**SITE PLAN REVIEW SHEET
ENVIRONMENTAL VARIANCE REQUEST ONLY**

CASE: SP-2019-0189D

PROJECT NAME: XSpace Group

DESCRIPTION OF VARIANCE:

Existing Conditions Exhibit

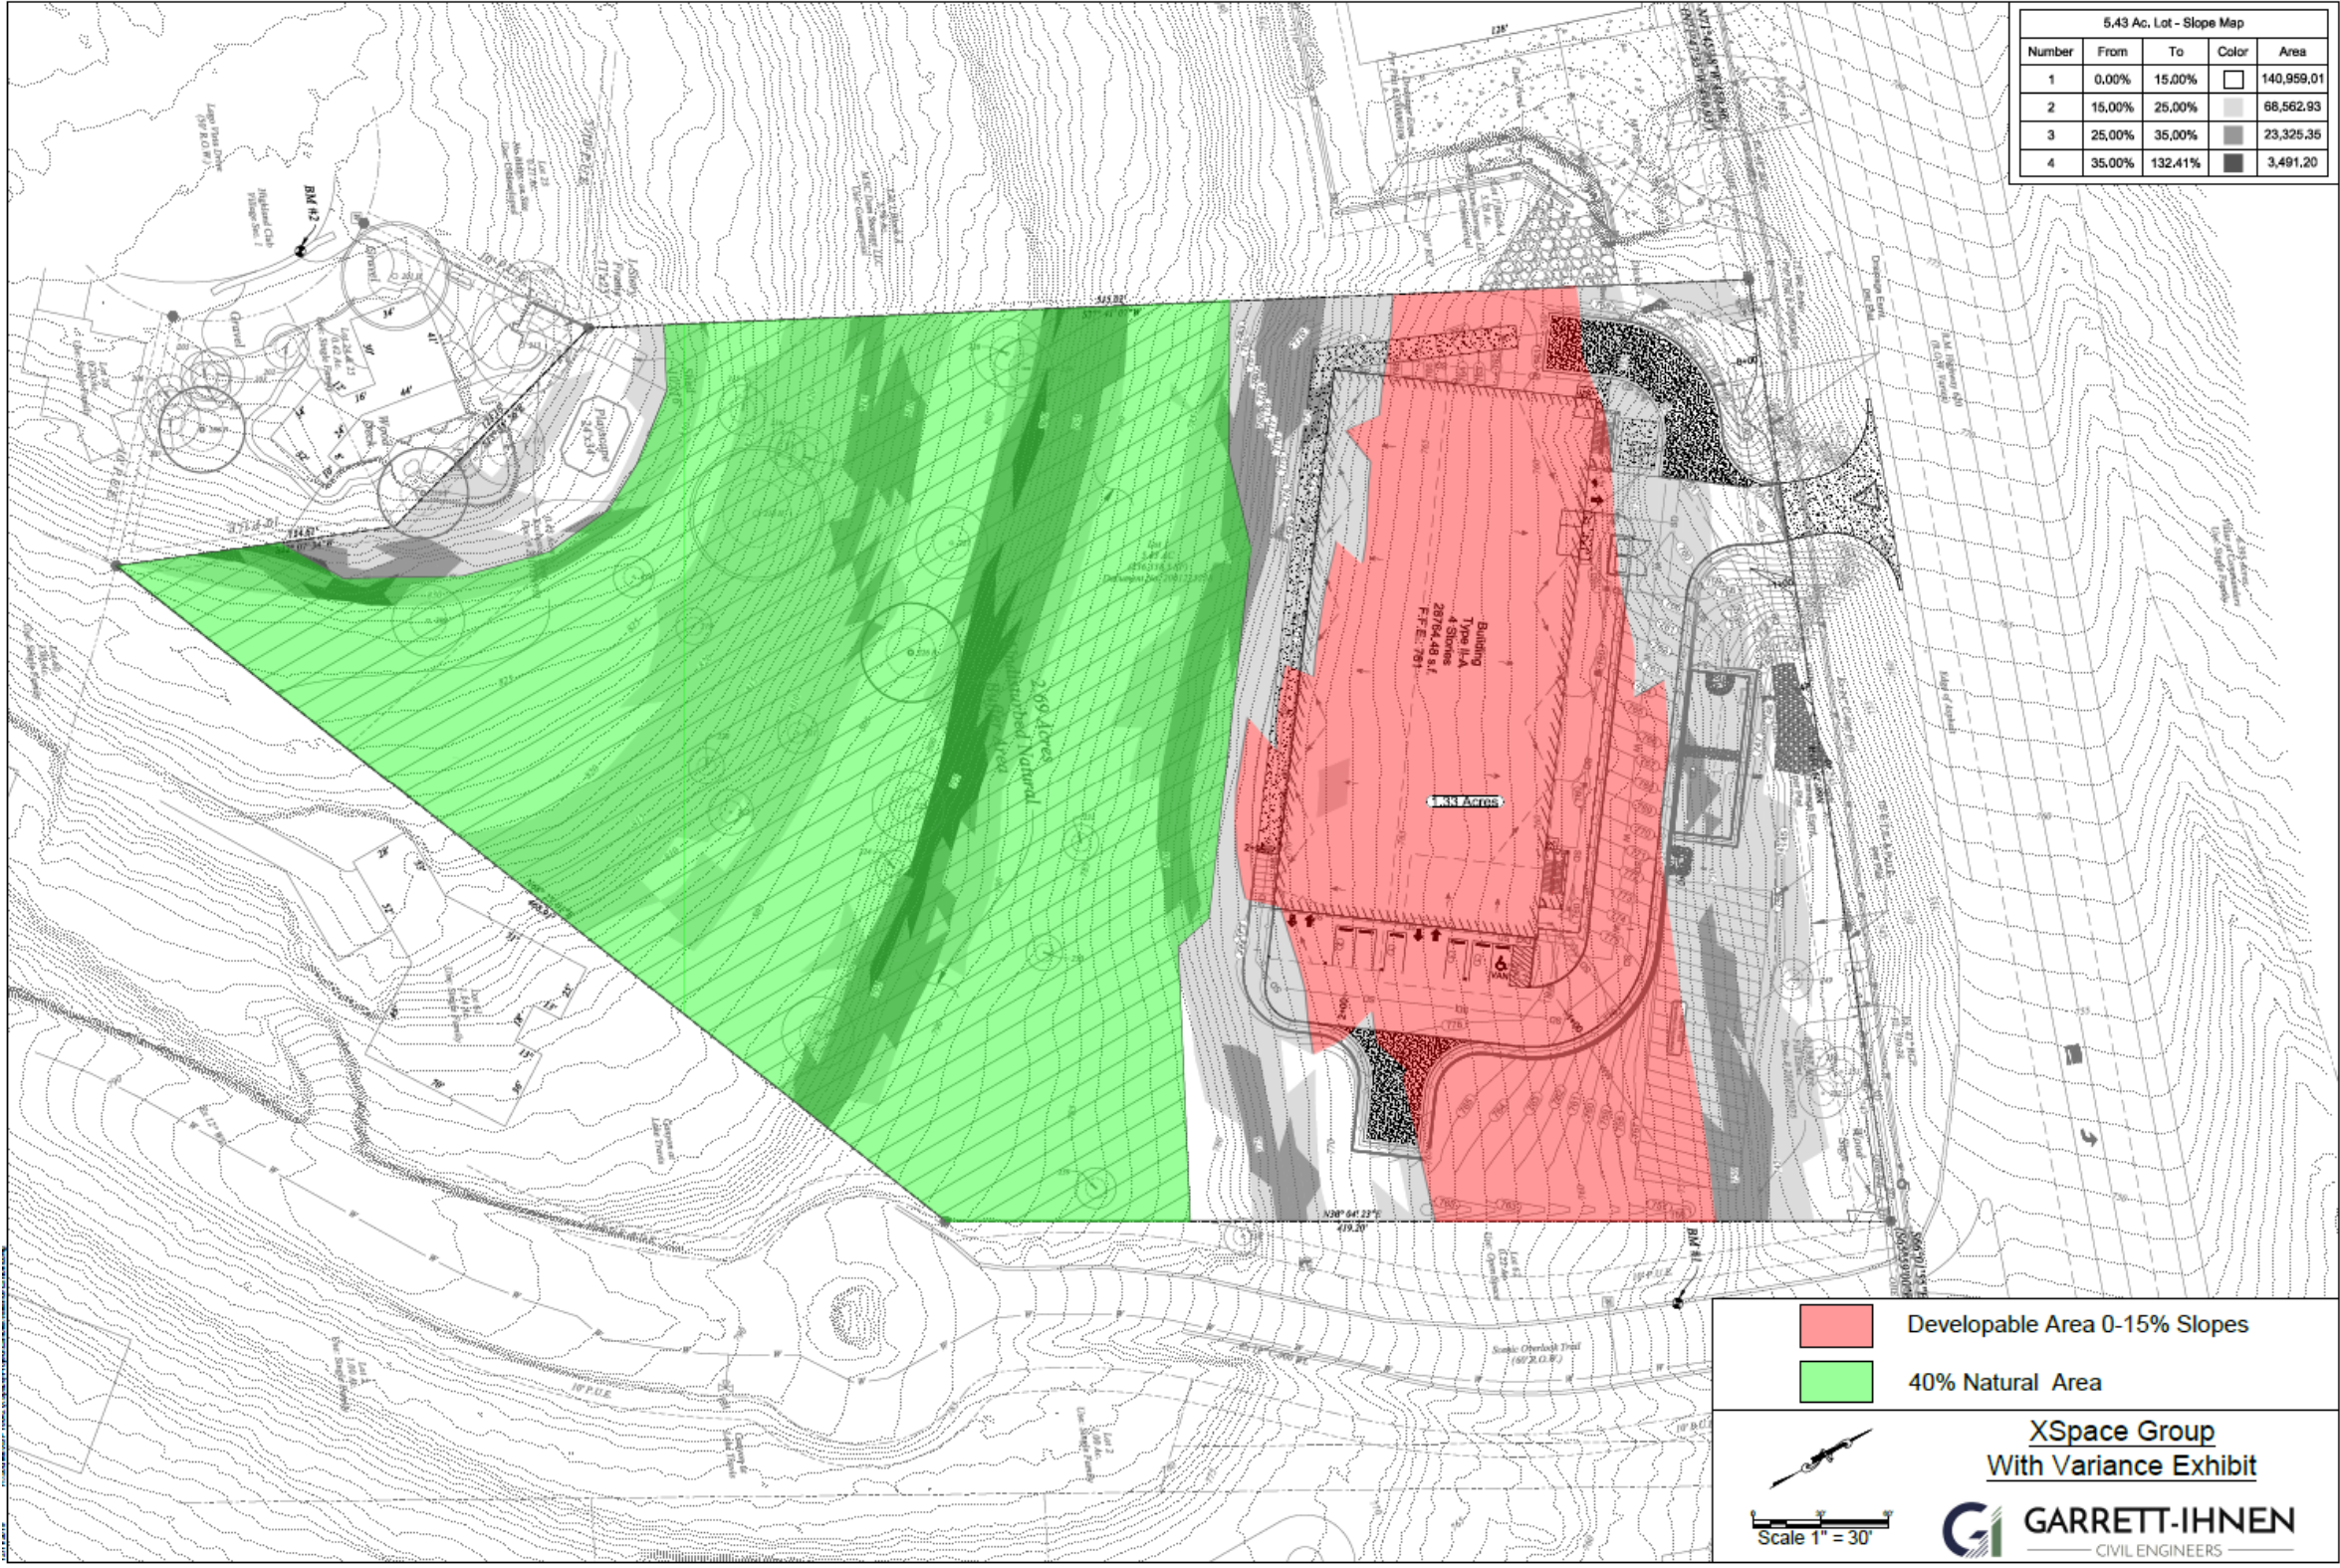
0-15% Slope Area Developable with a Variance
